INDESIT company

Model type:
MBA4533NF

Commercial code:
F029855

0999342: Aluminium separator dimentions

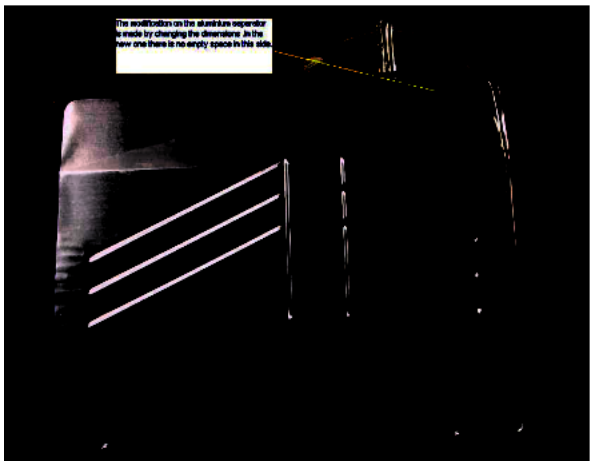
Modification on the aluminium separator is made by changing the dimentions. On the new one there is no empty space at the corner.Spare part code remain the same.

0999344: length of rezistance

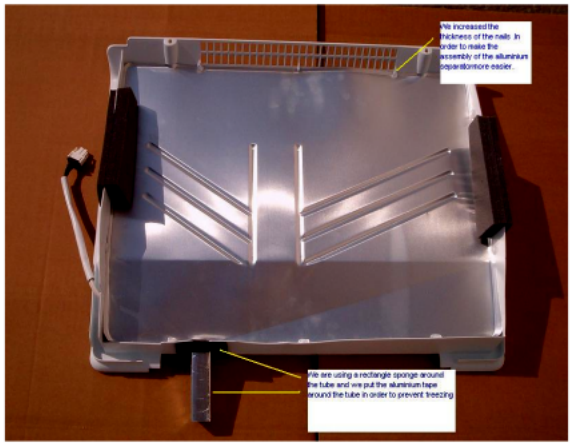
Length of rezistance which is placed on aluminium seperator has been increased.
